# RE: C-108, SWD APPLICATION <u>FEDERAL T SWD #1</u>- API#: 30-015-26404 Unit Letter "A" Section 12 T18S R27E Eddy County, New Mexico

## **APPLICATION FOR AUTHORIZATION TO INJECT**

## RE: Federal T SWD No. 1 (API 30-015-26404) SWD-1135

# RE: REQUEST BY HOLLYFRONTIER TO DENY LIME ROCK'S REQUEST TO INCREASE INJECTION PRESSURES AT FEDERAL T SWD#1 (API # 30-015-26404)

Figure 1:

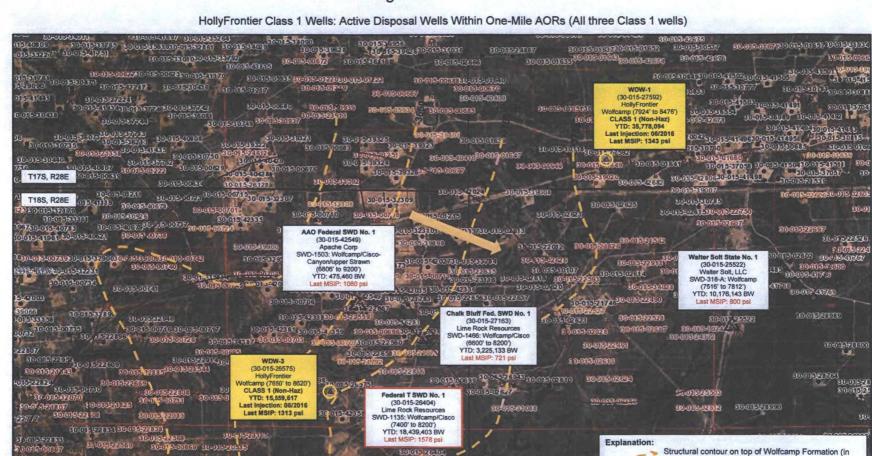
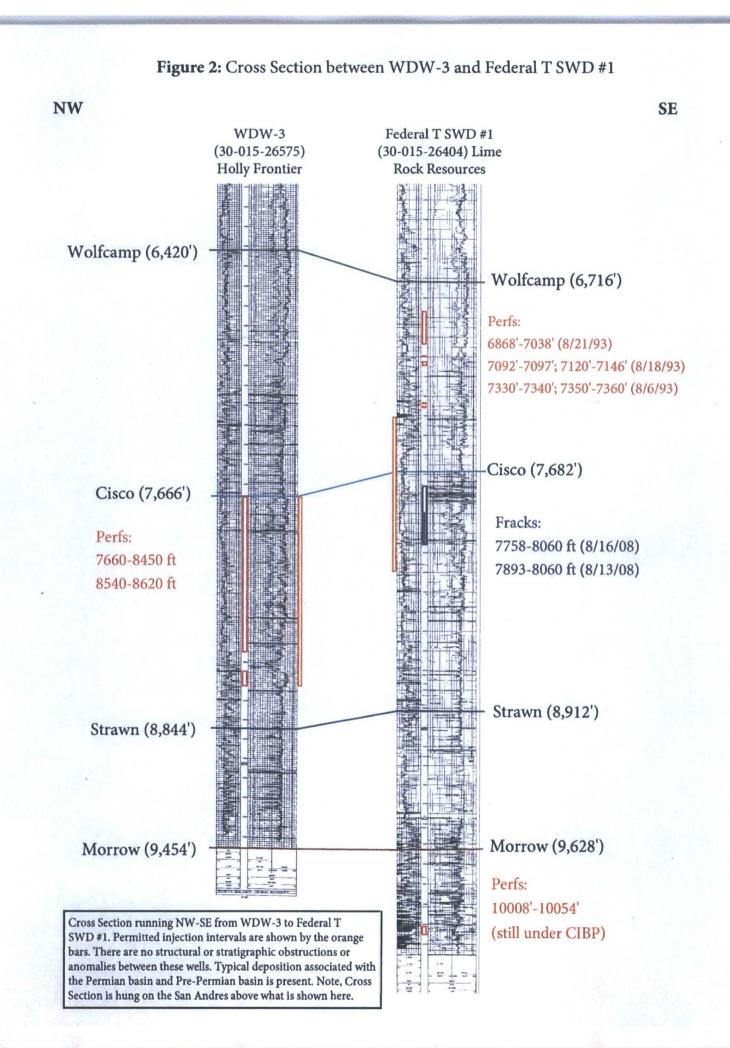
As seen in Figure 1, there are only approximately 2,500 feet separating HNFR's WDW-3 from Lime Rock's Federal T SWD #1, and both wells have completions in the same Cisco zone. The Federal T SWD #1 perforations in the Cisco Formation range from 7,685' to 8,060', and the WDW-3 Cisco perforations run from 7,666' to 8,620'. This overlap allows pressure fronts (and fluids) to migrate from the Lime Rock SWD to HNFR's WDW-3, potentially impairing the function of WDW-3.

# WELL COMPLETION DIAGRAM PROVIDED IN LIME ROCK'S REQUEST FOR PRESSURE INCREASE SHOWNING ZONES OF HYDROFRACTURING IN FEDERAL T SWD#1

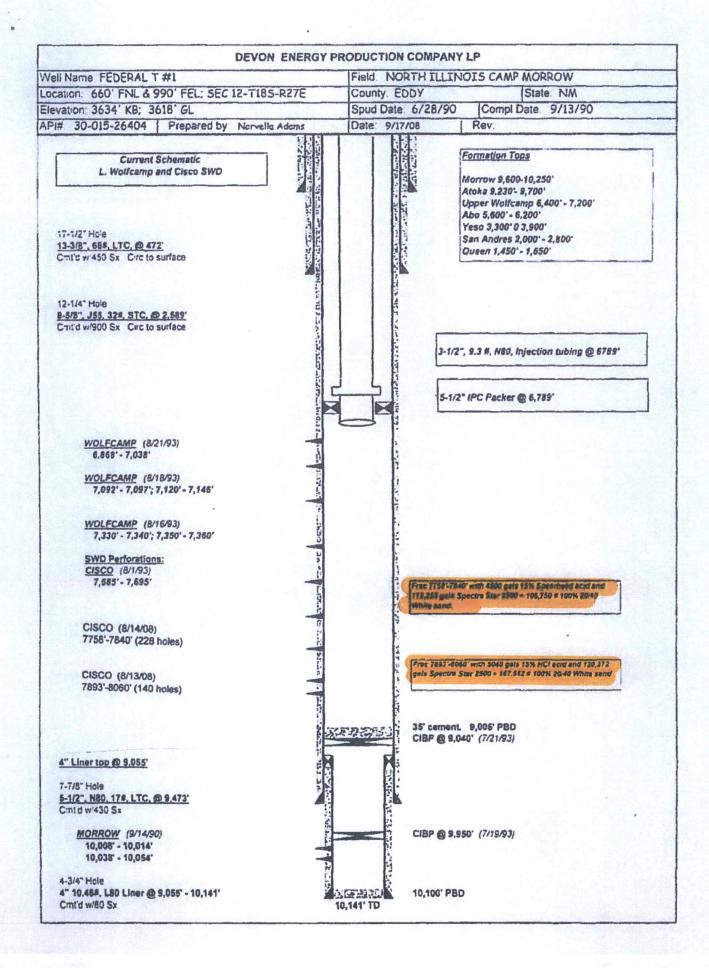
These fracture jobs are also noted in the well diagram submitted as part of Lime Rock's May 2017. pressure increase application (see Attachment B).

It is clear that the reason that Lime Rock observed that "The formation pressure did not break at a maximum surface pressure of 2681 psi (bottom hole pressure of 4140 psi)..." during their SRT is that the formation had already been broken during the hydrofracturing work done in 2008. For these reasons the step rate test results and conclusions are invalid and cannot form a defensible technical basis for Lime Rock's IPI request.
